Department of Environmental Protection

OCD-SW-00-0555

Orange County - SW
Keene Road Disposal/Buttrey Development
Class III Landfill - Construct & Operate
Permit Application Nos. SC48-0165969-001 and SO48-0165969-002

SUBJECT: Buttrey Development Project
Deflection Liner Installation Plan
Revised November 16, 2000

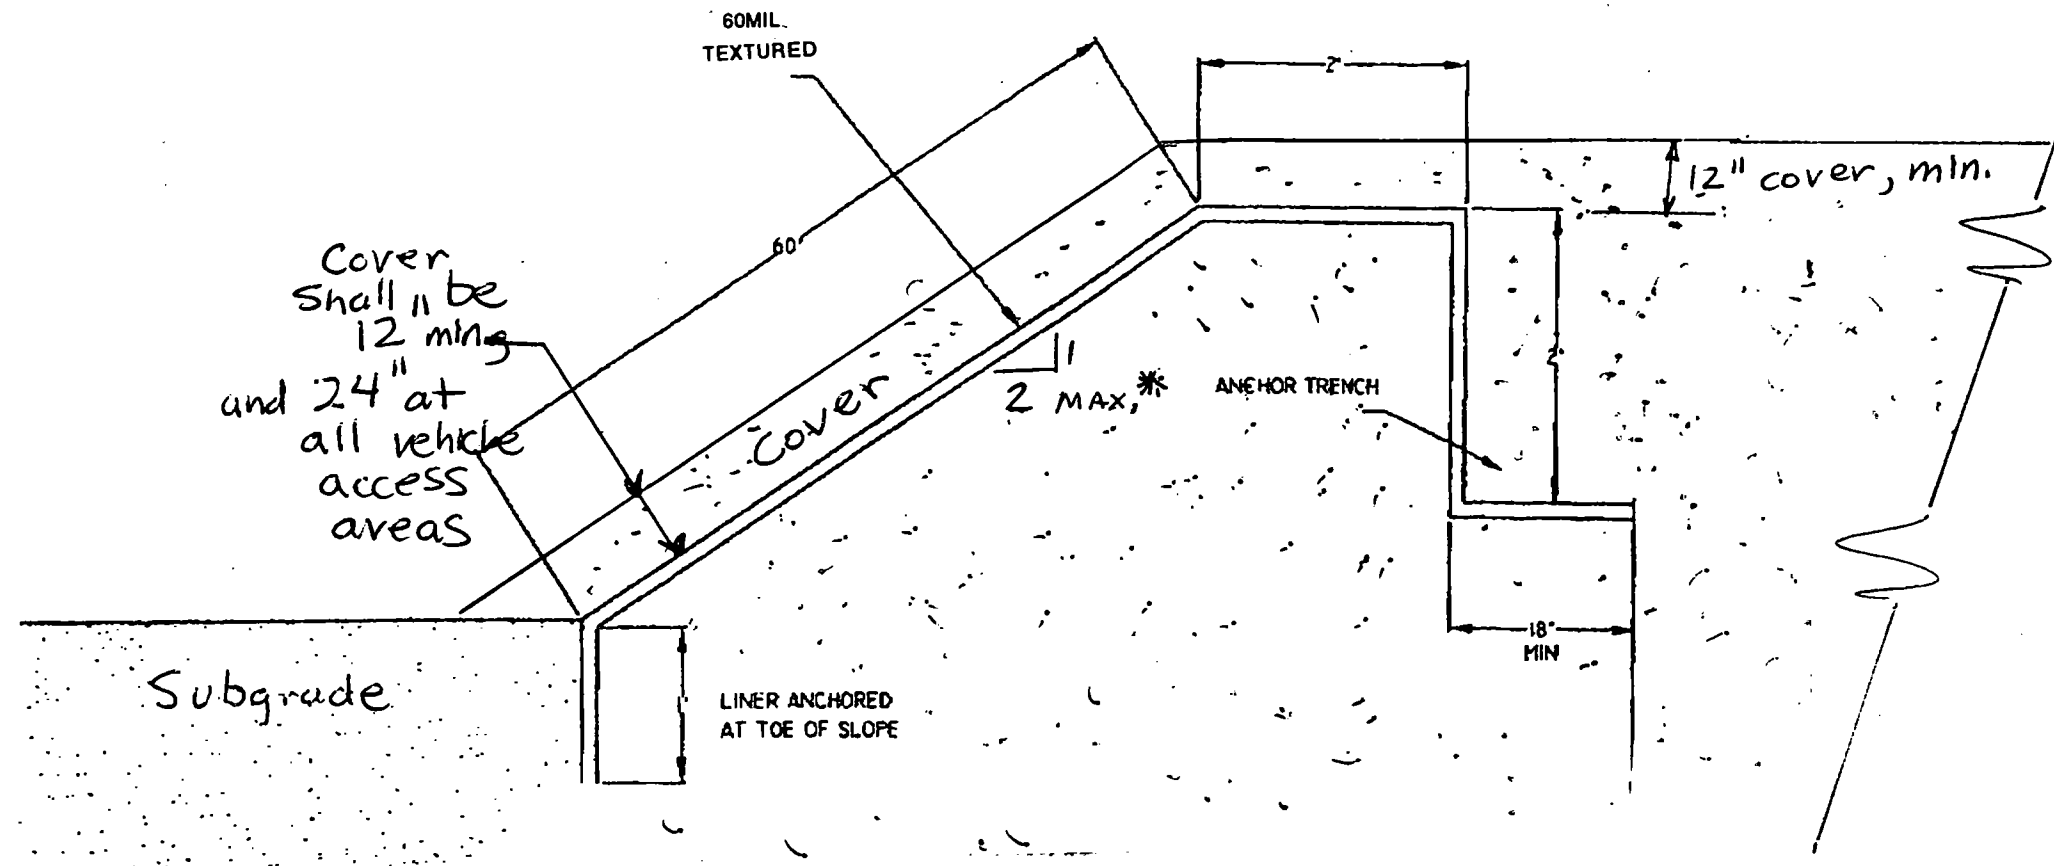
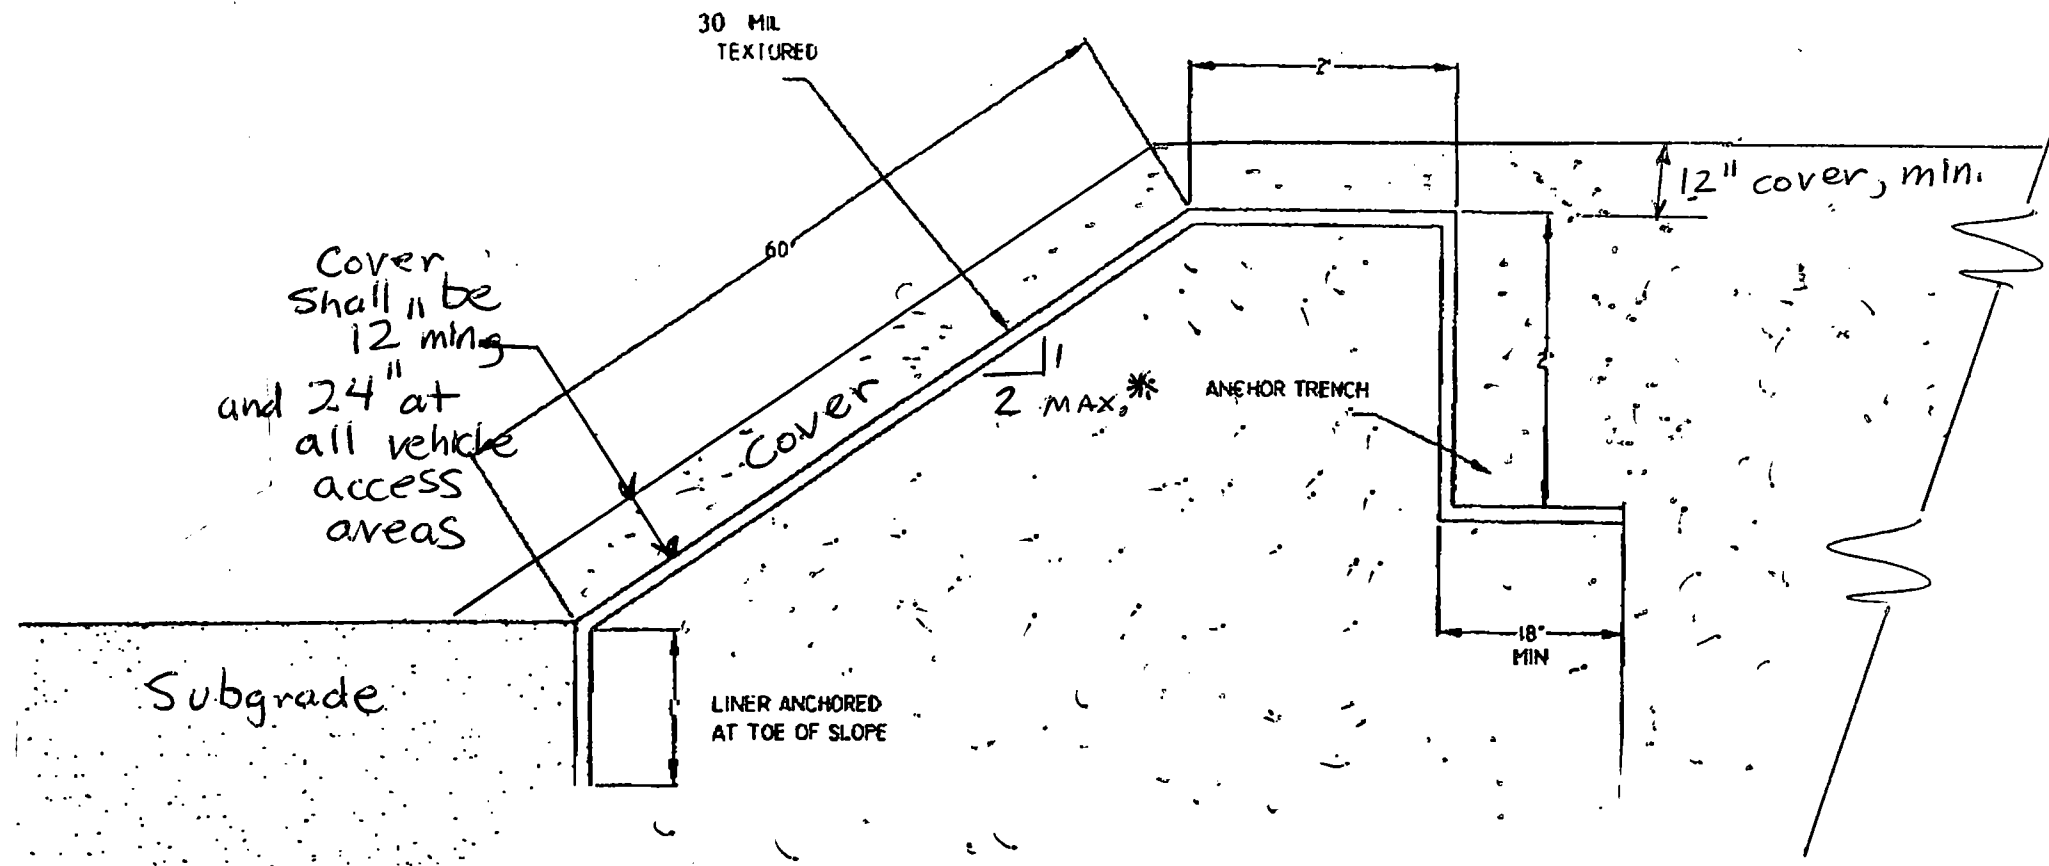
2. Testing the slope stability using the direct shear test is appropriate for the geomembrane and the overlying cover soils. However, the text states the test will be for the geomembrane and the underlying soils. Please clarify.

- 1) Side Slope shall be determined from direct shear test with geosynthetic, subgrade, & cover soils
- 2) Refer to Liner QA/QC Plan For all testing requirements.

- 1) Side Slope shall be determined from direct shear test with geosynthetic, subgrade, & cover soils
- 2) Refer to Liner QA/QC Plan for all testing requirements.

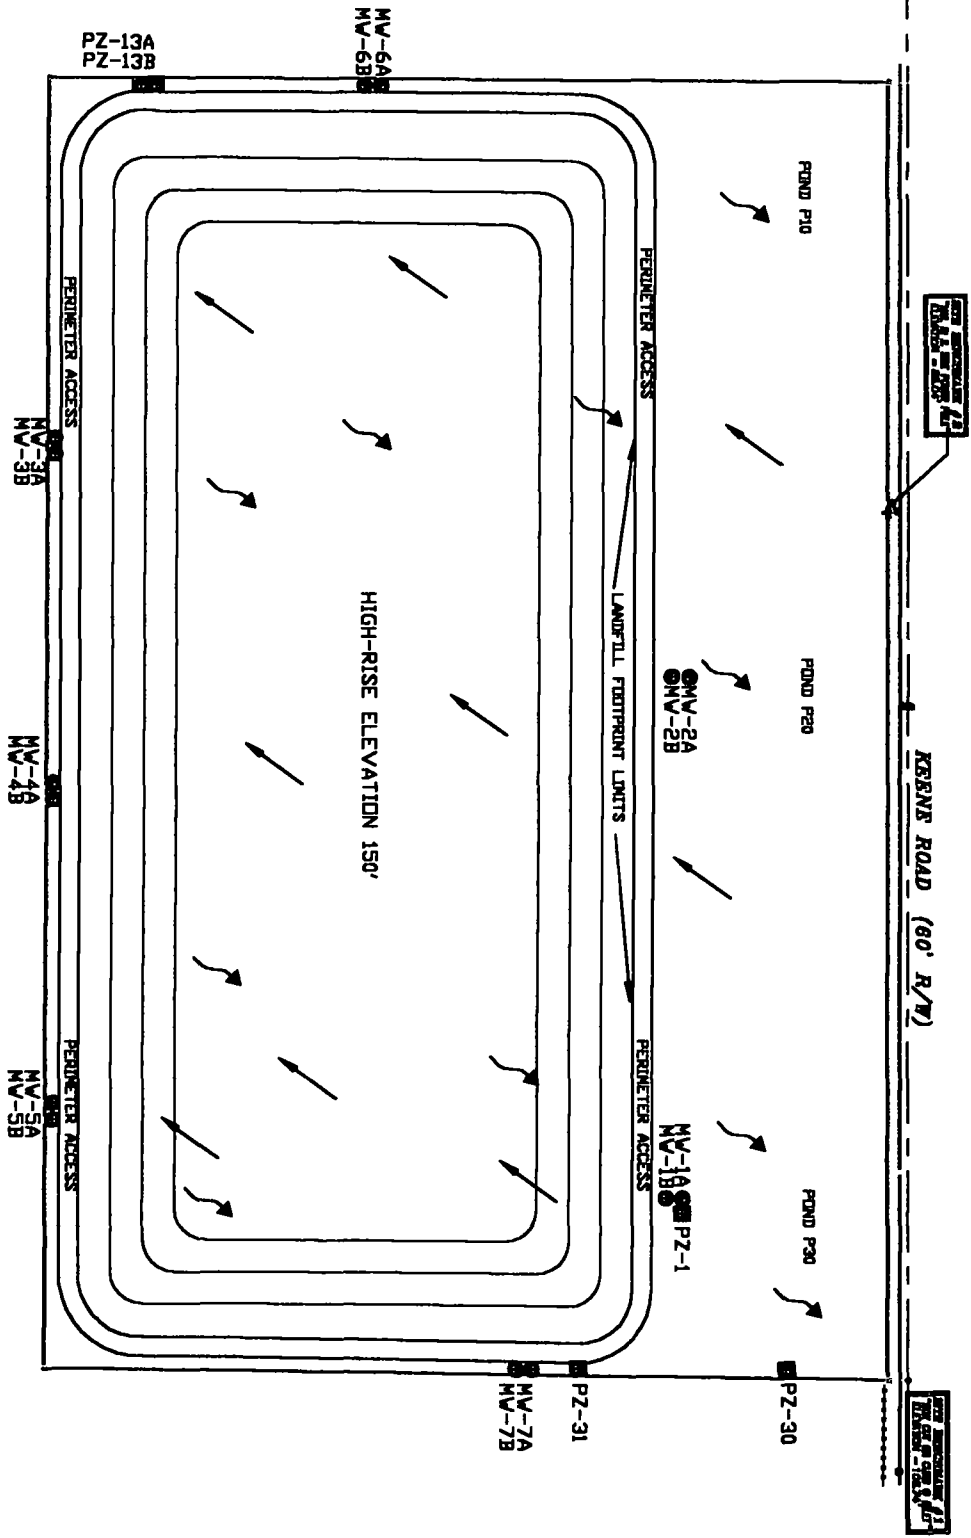
Comment 20. Comment 20 is incomplete. Based on analysis of the "perched" and surficial aquifer ground water elevations and flow directions and the site lithology, the technical review staff does not concur with the number of proposed monitoring wells, the proposed monitoring network are recommended:

Response 20. The revised Figure 4 and Table 2 from the proposed Monitoring Plan are attached as Exhibit B and include the following changes in the order described above:

- MW-4 & MW-6 as previously shown on Figure 4 have been deleted.
- The location of MW-7 has been shifted 250 feet to the north of it's originally proposed location. MW-7 has been renamed as MW-7A.

- MW-1 has been renamed PZ-1. Earlier references to a PZ-1 were for an off-site well/piezometer used of ground water level information only. This well/piezometer which is located just south of the property line will no longer be used or referenced as PZ-1 and has been removed from Figure 4. In addition to newly assigned PZ-1, site piezometers PZ-13A, PZ-13B, PZ30, & PZ31 are shown on Figure 4. These five piezometers will be used as ground water level stations for "perched" ground water conditions.

- Groundwater monitoring "clusters" are now proposed at each monitor well location. As shown on Figure 4, seven monitor well cluster locations are shown.

- Each of the seven shallow wells (denoted by A) are screened for twenty feet from elevation 57 to 37 NGVD. Each of the deeper wells (denoted by B) are screened for ten feet from elevation 20 to 10 feet NGVD. Refer to the revised Table 2 found in Exhibit B for more details.

- The revised Figure 4 shows each cluster location as well as the renumbering scenario used.

BASE ELEVATIONS VS GROUNDWATER ELEVATIONS & FLOW DIRECTION
FIGURE 1

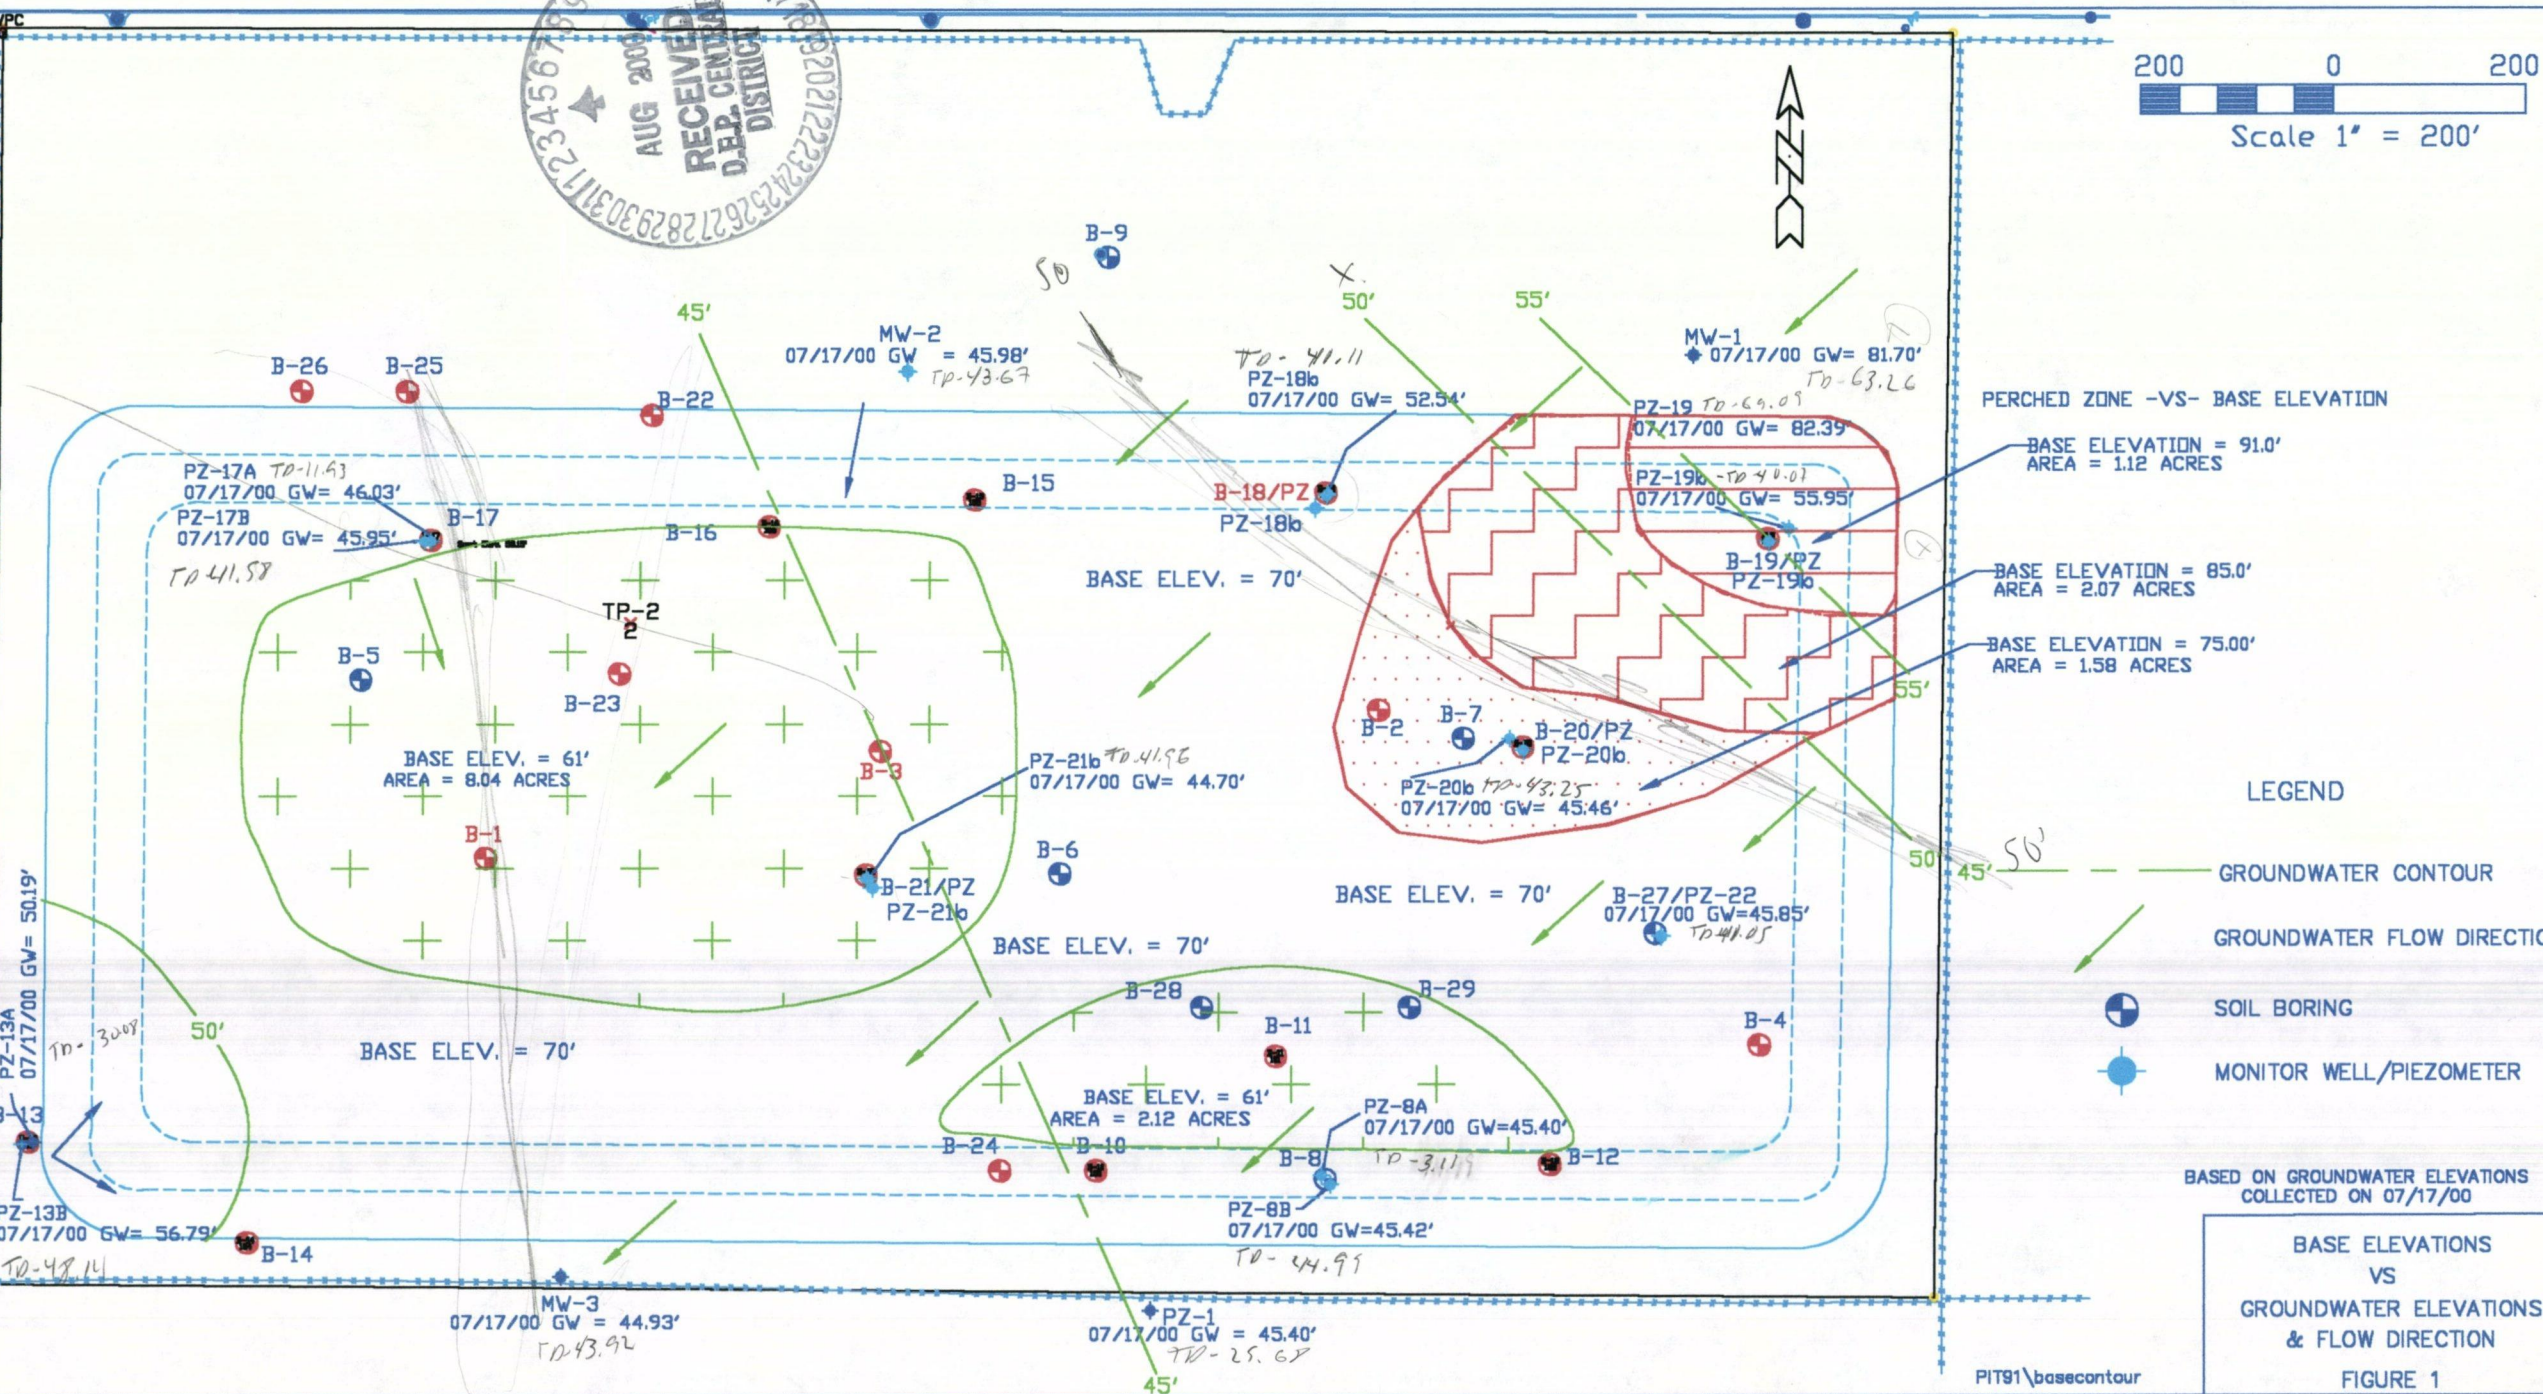
Comment 17. Comment 17 is incomplete. Figure 1 depicts the ground water elevation of 52.54' referenced to the National Geodetic Vertical Datum of 1929 (NGVD) at piezometer PZ-18B between the 45 foot and 50 foot contour lines. Additionally, Figure 1 depicts the ground water elevation of 44.70 feet NGVD at piezometer PZ-21B and the ground water elevation of 44.93 at monitoring well MW-3 between the 50 foot contour line in the southwest corner of the site and the 45 foot contour. Further, a 5 foot contour interval is too great. Please use a 2 foot contour interval and revise Figure 1 accordingly.

Comment 17 is incomplete. Figure 1 depicts the ground water elevation of 52.54 feet referenced to the National Geodetic Vertical Datum of 1929 (NGVD) at piezometer PZ-18B between the 45 foot and 50 foot contour lines. Additionally, Figure 1 depicts the ground water elevation of 44.70 feet NGVD at piezometer PZ-21B and the ground elevation of 44.93 at monitoring well MW-3 between the 50 foot contour line in the southwest corner of the site and the 45 foot contour. Further, a 5 foot contour interval is too great. Please use a 2 foot contour interval and revise Figure 1 accordingly.

Response 17. Attached as Figure 1 is a Base Elevation vs Groundwater Flow Direction Map for the 40-45 foot flow zone at a reduced interval. This figure contains the location of all site soil borings along with all monitor wells and piezometers associated with that flow zone. The flow direction was derived using groundwater data collected in site wells on August 25, 2000.

Response 17. Attached as Figure 1 is a Base Elevation vs Groundwater Flow Direction Map for the 40-45 foot flow zone. This figure contains the location of all site soil borings, monitor wells and piezometers as well as the recently installed piezometers and soil borings. Four of the five recently installed piezometers were installed as clusters adjacent to existing site piezometers as follows: PZ-18b installed adjacent to PZ-18 (reference boring B-18). PZ-19b installed adjacent to PZ-19 (reference boring B-19). PZ-20b installed adjacent to PZ-20 (reference boring B-20). PZ-21b installed adjacent to PZ-21 (reference boring B-21). PZ-22 (reference boring B-27). The flow direction was derived using groundwater data collected in all site wells on July 17, 2000.
